ADDENDUM #1
for
IN000A Site - Remediate Conduits and Fiber Cabling – IN – North Section
Indiana University Indianapolis
Indianapolis, Indiana
IU 20250357

ADDENDUM #1

This addendum forms a part of and modifies the Bidding Requirements, Contract Conditions, and the Construction Documents released on February 6th, 2026, by Design 27 for the IN000A Site - Remediate Conduits and Fiber Cabling – IN – North Section. Acknowledge receipt of this addendum by initialing the appropriate location on the submitted bid form:

TYPICAL NEW HANDHOLE LOCATION WITH GROUND

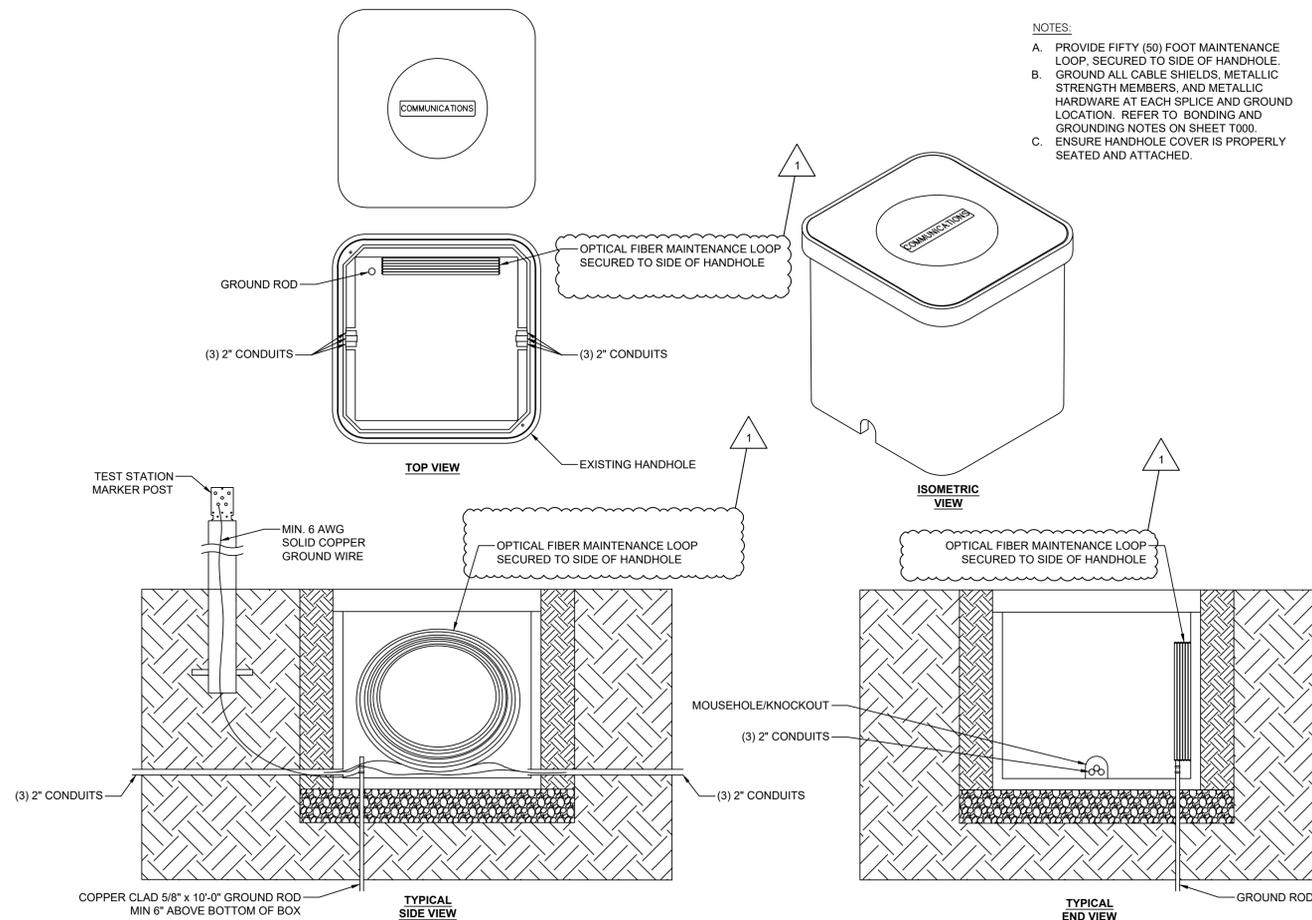
NOTE: There was an error in the detail for grounding handholes which has been corrected and re-issued with this addendum.

Sheet TN001

Made corrections to notes in “TYPICAL NEW HANDHOLE LOCATION WITH GROUND” detail.

- NOTES:
- A. PROVIDE FIFTY (50) FOOT MAINTENANCE LOOP. SECURED TO SIDE OF HANDHOLE.
 - B. GROUND ALL CABLE SHIELDS, METALLIC STRENGTH MEMBERS, AND METALLIC HARDWARE AT EACH SPLICE AND GROUND LOCATION. REFER TO BONDING AND GROUNDING NOTES ON SHEET T000.
 - C. ENSURE HANDHOLE COVER IS PROPERLY SEATED AND ATTACHED.

TYPICAL EXISTING HANDHOLE LOCATION WITH GROUND

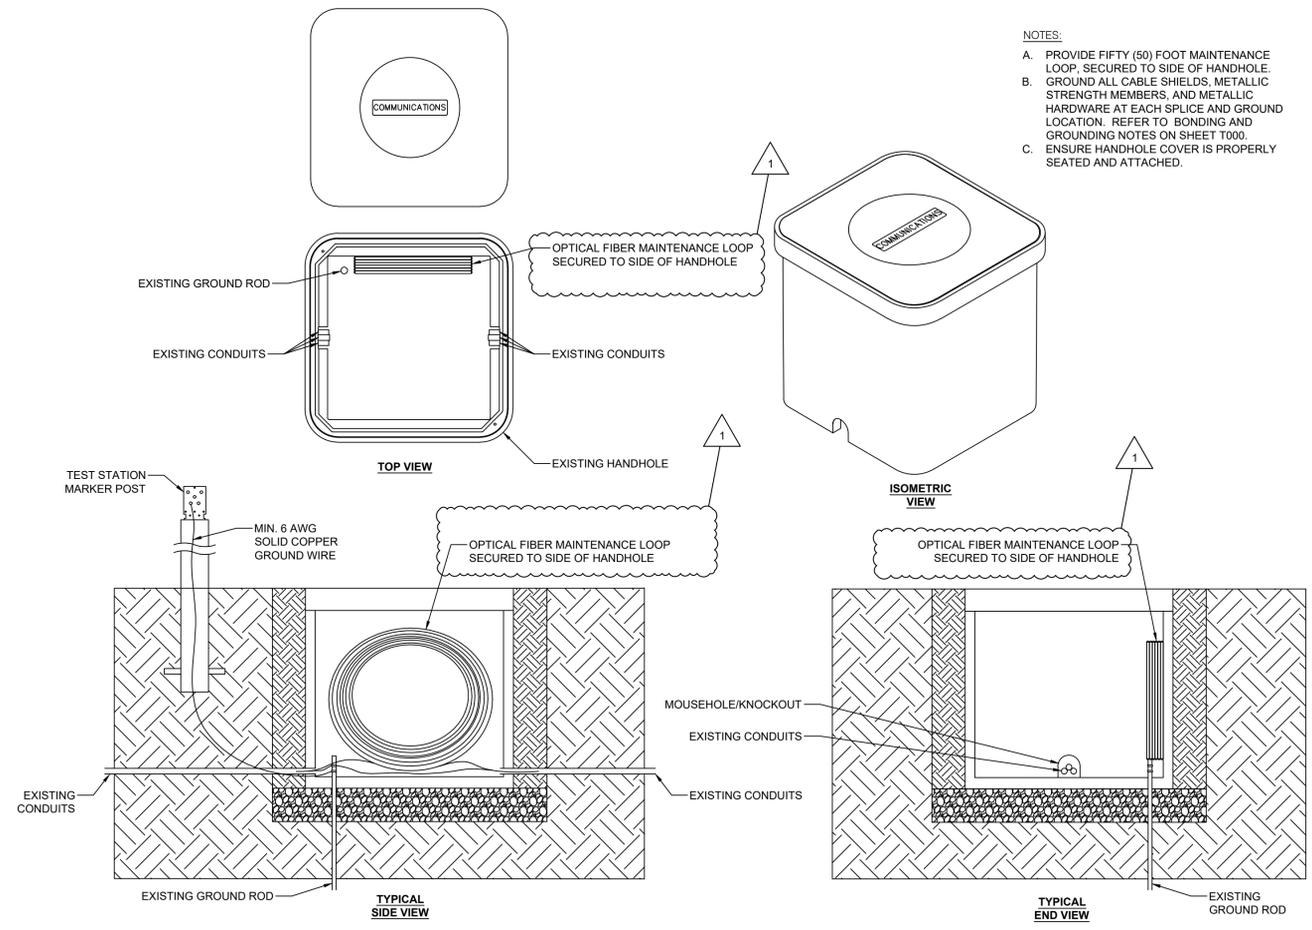
Sheet TN002

Made corrections to notes in “TYPICAL EXISTING HANDHOLE LOCATION WITH GROUND” detail.

- NOTES:
- PROVIDE FIFTY (50) FOOT MAINTENANCE LOOP, SECURED TO SIDE OF HANDHOLE.
 - GROUND ALL CABLE SHIELDS, METALLIC STRENGTH MEMBERS, AND METALLIC HARDWARE AT EACH SPLICE AND GROUND LOCATION. REFER TO BONDING AND GROUNDING NOTES ON SHEET T000.
 - ENSURE HANDHOLE COVER IS PROPERLY SEATED AND ATTACHED.
